From: Joel Clarke
Sent: 17 October 2013 11:58
To: 'Gayetree Ramkorun'
Cc: 'jalbon@bba.star.co.uk'; Ivor Meredith; Gareth Mills
Subject: RE: extremely urgent S247070 K15

Thanks for the reply: we respect the BBA's position. Unfortunately in this case we still feel some of our points are not being fully considered, particularly those relating to the phrase 'buildings above 18m' which has been placed on the first page. We have some additional comments in **red** below, which will hopefully clarify what we mean.

Diagram C6 Height of top storey in building

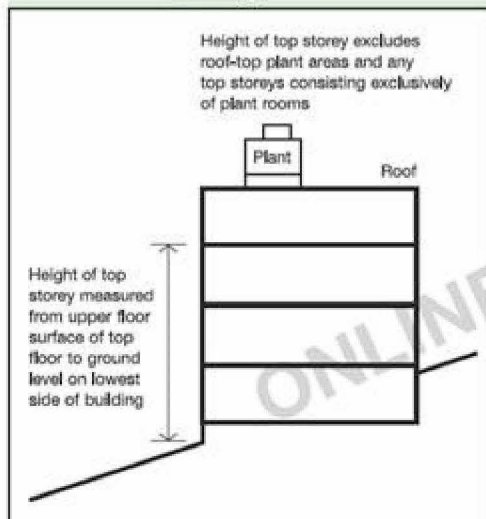
Secondly, the requirement in Part B is not for 'buildings over 18m'. The requirement relates to those buildings which have habitable storeys greater than 18m from ground level (where a storey's height is defined as the height at the top of the floor of the storey, i.e. the bottom of the storey). This means the minimum height of a building subject to the BS 8414 / limited combustibility requirements is likely to be at least 21m. As top storeys containing plant rooms (not considered 'habitable') are quite common it is not unusual for a building to be 25m in height and still not subject to the requirement. **I believe we are saying up to 18 m and the tested one can be used on over 18 m, so I don't understand where the 21 and the 25 are coming from?**

The problem we see is that the phrase 'buildings above 18m' is vague and could easily be misunderstood. The term 'building height' as understood by most people, and 'storey height' as defined in Approved Document B, are totally different things. The height of the building, as commonly understood by most people, is the length from ground level to the final surface, i.e. the top of the roof. However, the BS 8414 / limited combustibility requirement applies to storey height, not building height. Please see diagram below, taken from Approved Document B2. I hope this helps explain:
